PLANNING & ZONING BOARD - CITY OF WILDWOOD
Special Magistrate – Lindsay C.T. Holt

Agenda
Regular Meeting
December 6, 2022 2:15 PM
City Hall Commission Chamber
100 N Main Street

7. PD 2205-001 Turkey Run PD Amendment

CONCEPT PLAN TURKEY RUN

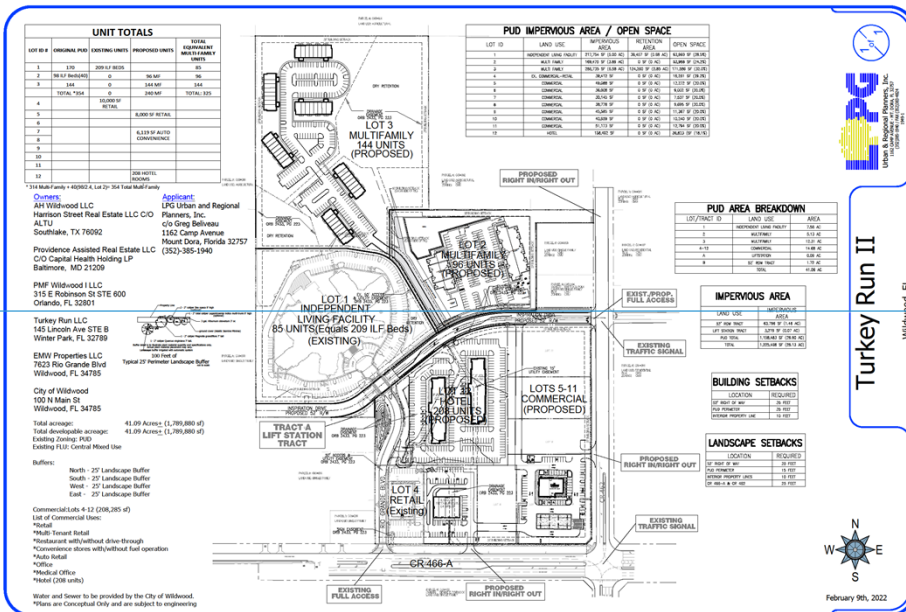
Commented [j2]: Conceptual Plan
 LDR 8.4(A)3 – Add zoning to adjacent parcel to the north and west side of the project.
 LDR 8.4(A)5 – Recreation facilities not provided on the concept plan.
 LDR 8.4(A)6 – Add the number of residential buildings.
 LDR 8.4(A)8 – Show all sidewalks on the concept plan.
 LDR 8.4(A)10 – Location of nearest potable water and sanitary sewer
 6. LDR 8.4(A)11 – Add time frame for final approval to be filed with the City of Wildwood for the phases..
 7. LDR 8.4(A)12 – Correct Zoning from PUD to CMU and add Neighborhood Design Standards.
 8. General Note: Label all exhibits

Commented [j7]: From City of Wildwood Utility Department - Exhibit shown does not show existing infrastructure. Add all water and sewer infrastructure to exhibit, to show all conflicts this change will have with the existing utility lines.

Commented [RR8]: Please submit a separate PDF of the concept plan and include all items listed in LDR Sec. 8.4
